8. Well Name and No.  
FARRELL FEDERAL 139. API Well No.  
30-041-1043110. Field and Pool or Exploratory Area  
CHAVEROO-SAN ANDRES11. County or Parish, State  
ROOSEVELT COUNTY, NM**12. CHECK THE APPROPRIATE BOX(ES) TO INDICATE NATURE OF NOTICE, REPORT, OR OTHER DATA**

Plugging Procedure  
Farrell Federal #13  
API - 30-041-10431  
Sec. 28, T7S, R33E, UL-D  
660' FNL 660' FWL

**Farrell Federal 13  
30-041-10431  
Ridgeway Arizona Oil Corp  
November 21, 2017  
Conditions of Approval**

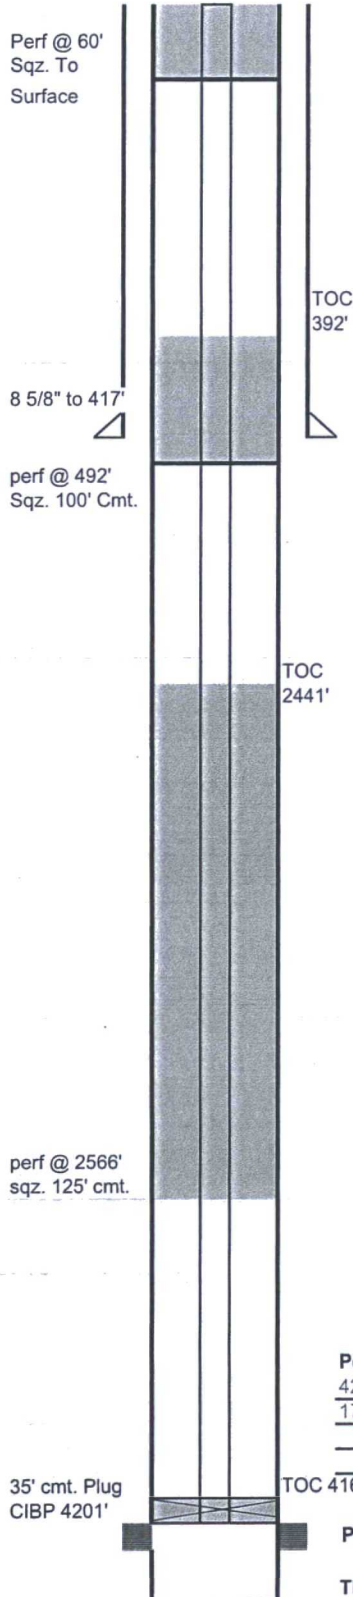
4196' (50' - 100' above top most perf)

2,200' (to seal the top of the Yates)

\* plug needed for salt section \*  
see COAS

392' (50' above and 50' below casing shoe)

1. Operator shall place CIBP at 4,196' (50'-100' above top most perf) and place 35' of Class C cement on top as proposed. WOC and TAG.
2. Operator shall perf and squeeze at 2,566'. Operator shall place a balanced Class C cement plug from 2,566'-2,200' to seal the top of the Yates formation. WOC and TAG.
3. Operator shall place a Class C cement plug from 1,900'-1,700' to seal the salt.
4. Operator shall perf and squeeze at 492' as proposed tagging plug at 367' to seal the surface shoe. WOC and TAG.
5. Operator shall shall perf and squeeze at 60' brining cement to surface.
6. See Attached for general plugging stipulations.
